DESCRIPTIVE REPORT

Descriptive Report to Accompany Hydrographic Survey H11074

Project OPR-P359-RA-01
Approaches to Seward, Alaska
Scale 1:20,000
August 2001

Figure 2. H11074 Junction Surveys

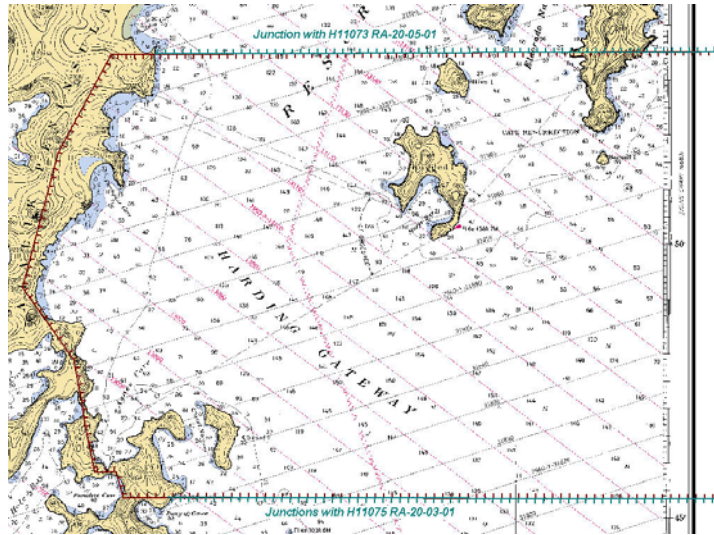
H11074 junctions with H10075 and H11073.⁷

Survey H11074 junctions well with survey H11075, with differences generally less than one fathom. Survey H11074 junctions well with survey H11073, with differences generally less than one fathom except for two areas. A sounding from Survey H11073 at 59°53'28"N, 149°23'47"W, shows a depth of 113 fathoms whereas the corresponding sounding from Survey 11074 shows a depth of 109 fathoms. Another sounding from Survey H11073 located at 59°53'28"N, 149°18'06"W shows a depth of 13.8 fathoms and its corresponding sounding from Survey H11074, approximately 10 meters away at location 59°53'28"N, 149°18'05"W shows a depth of 1.7 fathoms. In both cases, the discrepancies are due to the steep topography.⁸

Final comparisons will be made at the Pacific Hydrographic Branch (PHB).⁹

⁷ Junction were made during office processing. There was good agreement and "Joins" notes have been added to the smooth sheet.

⁹ Concur with clarification. Junction comparisons were made with H-11073 and H-11075 during office processing and found to be good. Soundings and depth curves are in good agreement.

Revisions from NOAA Hydrographic
Survey H11074

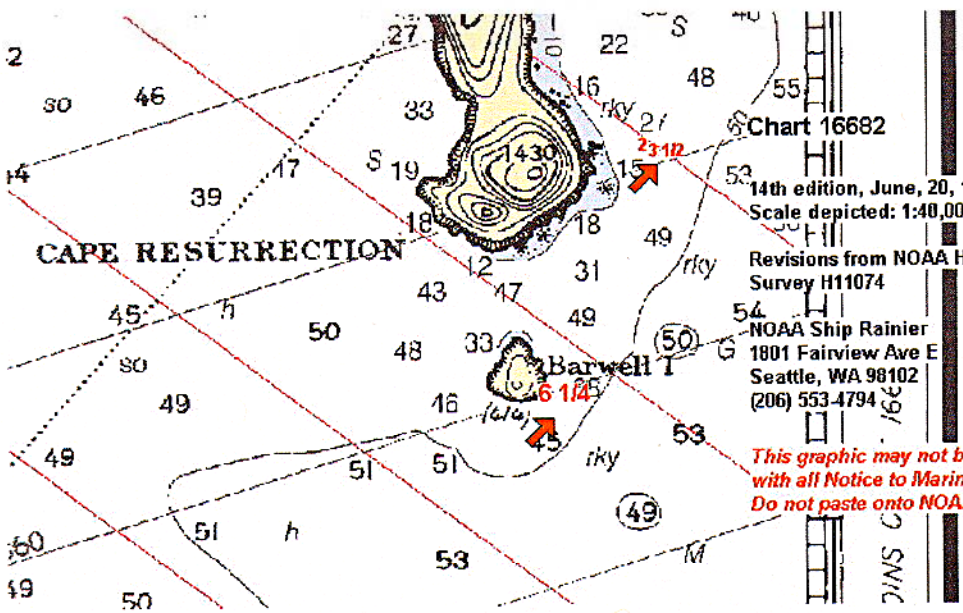
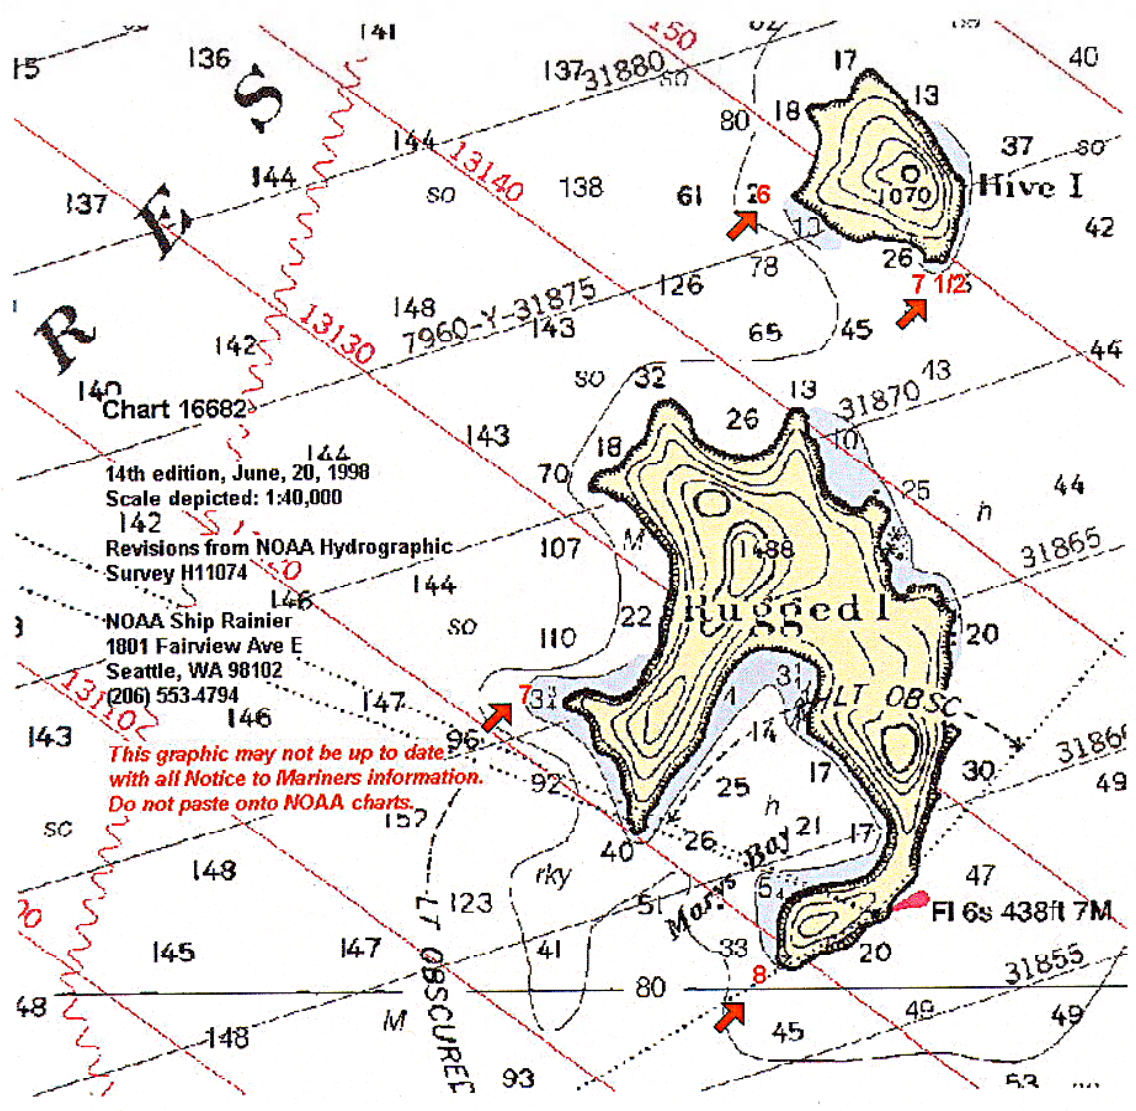
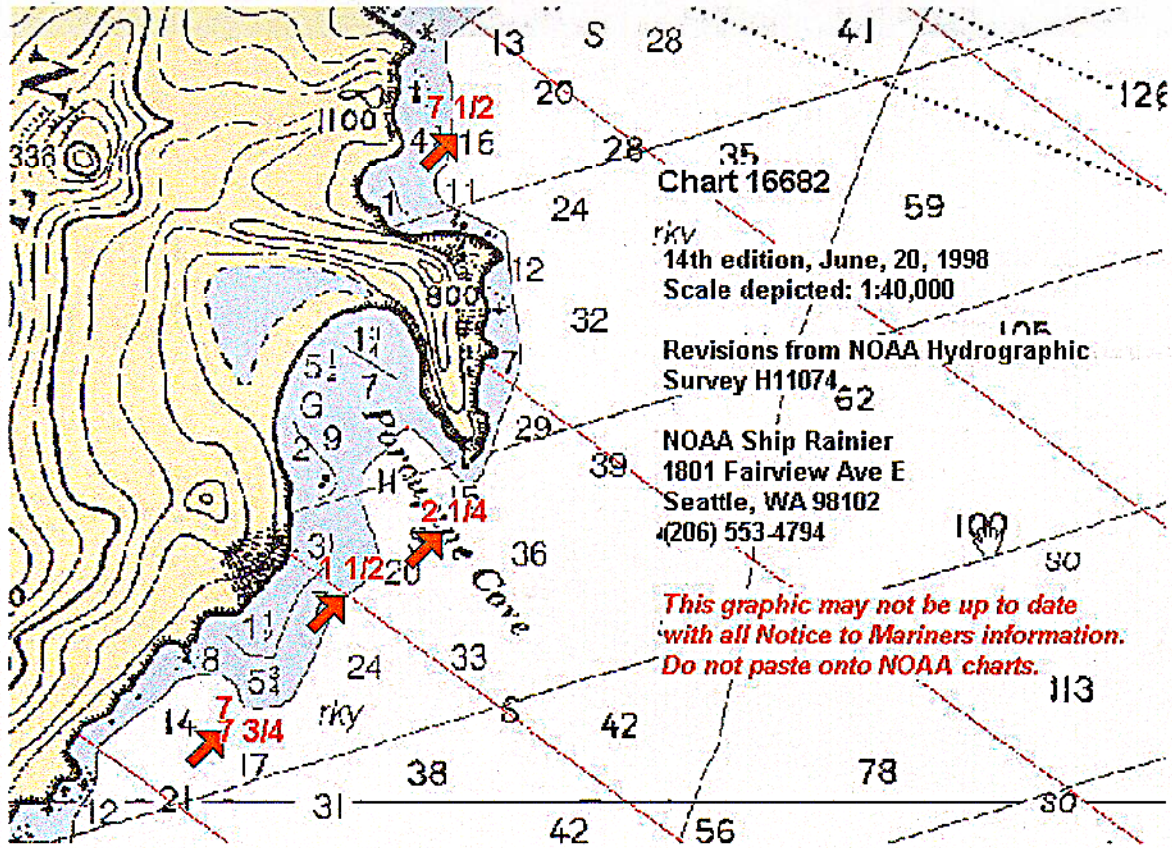
History **HISTORY**
LNM27/98--17TH CGD; AS OF MARCH 20, 1998 A SUBSURFACE OCEANOGRAPHIC INSTRUMENT MOORING HAS BEEN DEPLOYED IN POS.59 51 06.5, 149 29 54W. THIS MOORING EXTENDS TO WITHIN 50 FEET OF THE SURFACE AND WILL FOUL FISHING GEAR. CONTACT: TOM SMITH AT U OF AK, 907-224-5261.
LNM33/00-17TH CGD, 8/15/00; ADD DOTTED CIRCLE (500 YD RADIUS) WITH BLUE TINT 8 FM IN POS. POS.59 51 06.5, 149 29 54W.

Fieldnote **INVESTIGATION**
DATE(S): 08/21/01 (DN:233)
HYDROGRAPHIC SURVEY NUMBER: H11074
VN: 2120 TIME: 2337
INVESTIGATION METHODS USED: 100% SWMB
SURVEYED POSITION: LAT. 59/51/06.103N LON.149/29/56.580W
POSITION DETERMINED BY: DIFFERENTIAL GPS
INVESTIGATION SUMMARY: NOT FOUND AFTER USING 100% SWMB COVERAGE. COMMUNICATION WITH DR. SMITH AT UAF UNSUCCESSFUL. LETTER OF INQUIRY SENT TO USCG.
CHARTING RECOMMENDATION (HYDROGRAPHER): RETAIN AS CHARTED PENDING COMMUNICATION WITH EITHER DR. SMITH OR USCG.
EVALUATOR COMMENTS: THE BUOY HAD BEEN REMOVED PER PHONE CONVERSATION WITH TOM SMITH (U OF AK.) 12/02/2005. REMOVE DOTTED CIRCLE, TINT AND NOTES FROM CHARTS.

¹⁴ Concur with clarification. Correspondence was successful 12/02/05. According to Dr. Smith of the Univ. of Alaska, the buoy in question has been removed.
